TOWN OF NISKAYUNA
Planning Board and Zoning Commission
Agenda
February 13, 2023 7:00 PM

TOWN OF NISKAYUNA
Planning and Zoning Commission
Hybrid Meeting
Meeting Minutes
December 12, 2022

TOWN OF NISKAYUNA
Planning and Zoning Commission
Hybrid Meeting
Meeting Minutes
January 9, 2023

Grading Notes

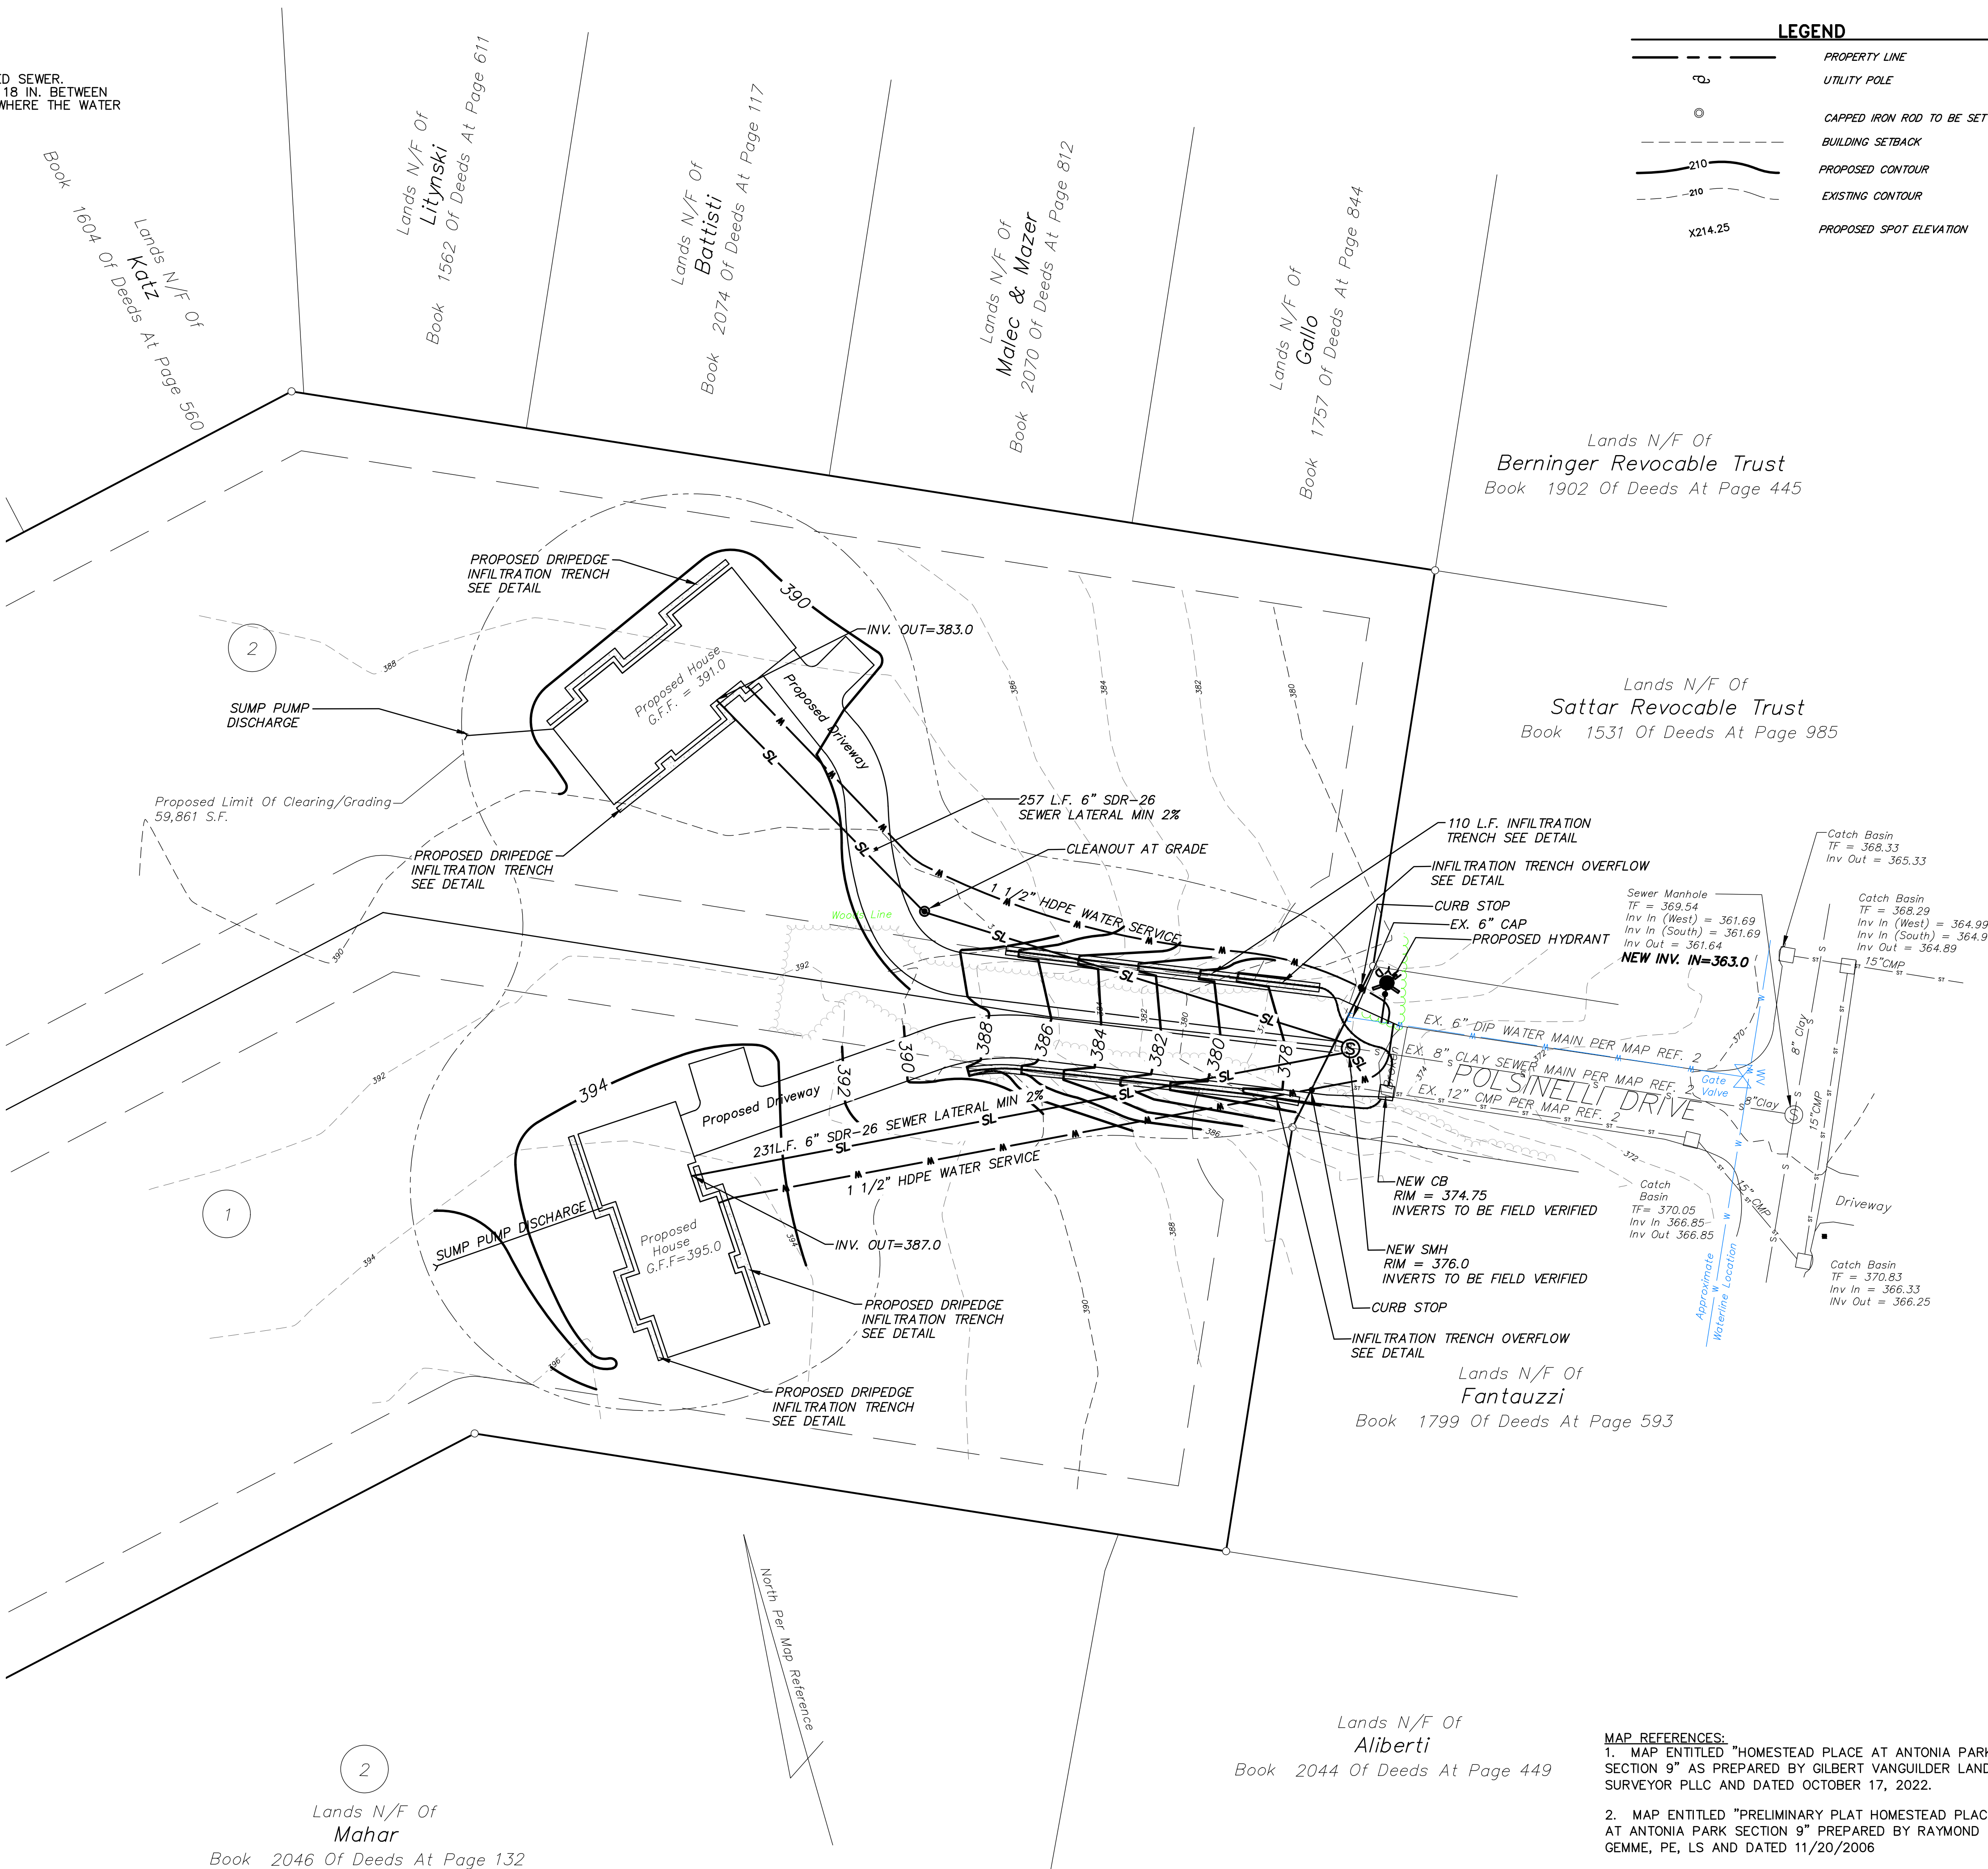
- The applicant shall treat the grading plan—submitted for the subdivision as advisory only, and shall submit grading plans for review by the Building Inspector on a lot-by-lot basis that are consistent with the Planning Board requirements for tree preservation.
